Appln No. 10/820,977

Reply to Office action of September 22, 2004

REMARKS/ARGUMENTS

FIG. 12

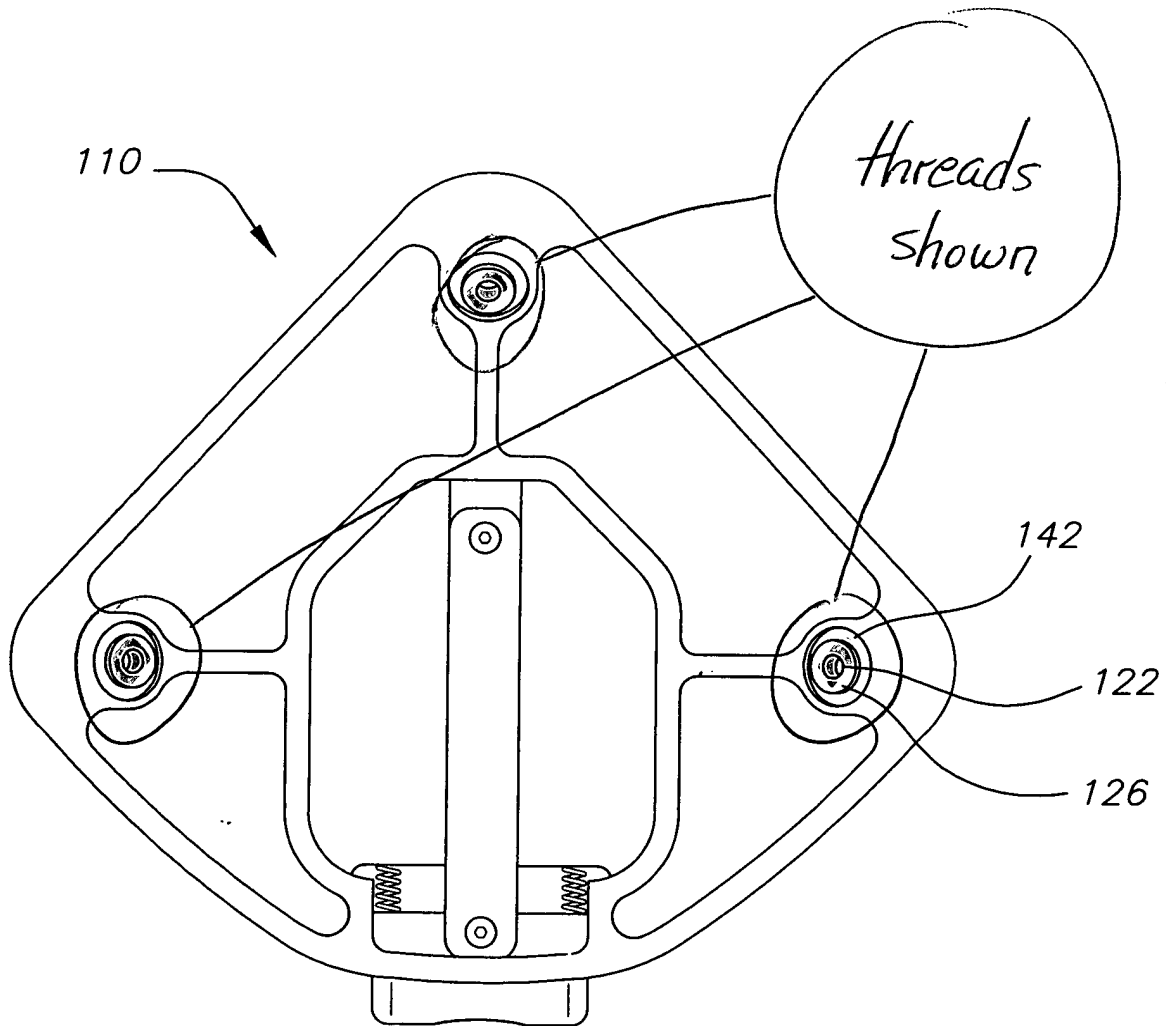
The Examiner also objected to the drawings under 37 CFR 1.83(a), requesting that the "threaded cylinder fastening means of claims 2 and 34, the textured legs of claims 6 and 9 and the wrap around legs of claims 7 and 10" be shown. FIG. 12 has been amended to more clearly show the threaded cylinder fastening means and FIG. 14a has been added to more clearly illustrate the textured legs. Additionally, the specification has been amended as indicated above to more clearly elaborate on the inwardly projecting base of FIG. 14.
